### ROADWAY DESIGN BULLETIN 05-07

**DATE:** August 9, 2005

**SUBJECT:** Index 400 Modified Thrie Beam  
Requirement for Thrie Beam Backup Plate at Non-splice Posts

**Modified Thrie Beam**

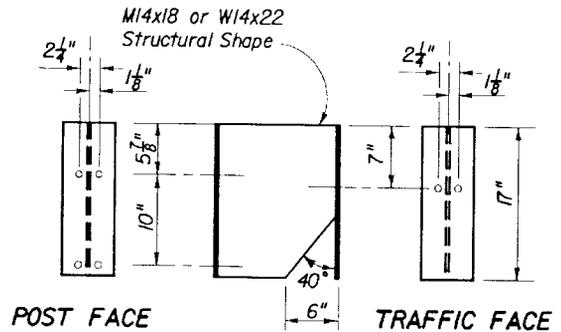
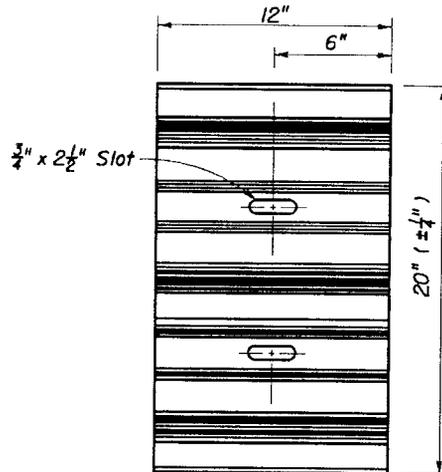
The Modified Thrie Beam Guardrail System detailed in Index 400 requires the installation of a backup plate at all non-splice post locations. The backup plate is a manufactured 12" section of Thrie Beam as shown in the attached drawing. This backup plate requirement is not specifically addressed in the 2004 Design Standards Index 400, nor is it addressed in the Design Standards Modifications. Districts are requested to take the actions below to insure the backup plate requirement is met. This only applies to Modified Thrie Beam guardrail systems with the Steel Modified Thrie Beam Offset Block. This does not apply to standard Thrie Beam systems with standard offset blocks, Bridge Traffic Railing (Thrie Beam Retrofit), and Thrie Beam Guardrail Approach Transitions to Bridge Traffic Rails. Note that use of the Modified Thrie Beam guardrail system throughout the state appears to be limited. Available pay item records indicate this guardrail system has only been used in District 7. However, these pay item records do not reflect possible installations made by Lump Sum contract.

*Back-up plate required behind rail elements at intermediate (non-splice) posts when steel offset block used.*

A 12 gage Thrie Beam Back-Up Plate, 12" x 20", (Rail Component RTB01a detailed in AASHTO-AGC-ARTBA "A Guide to Standardized Highway Barrier Hardware") is required at all post locations where a splice does not occur.
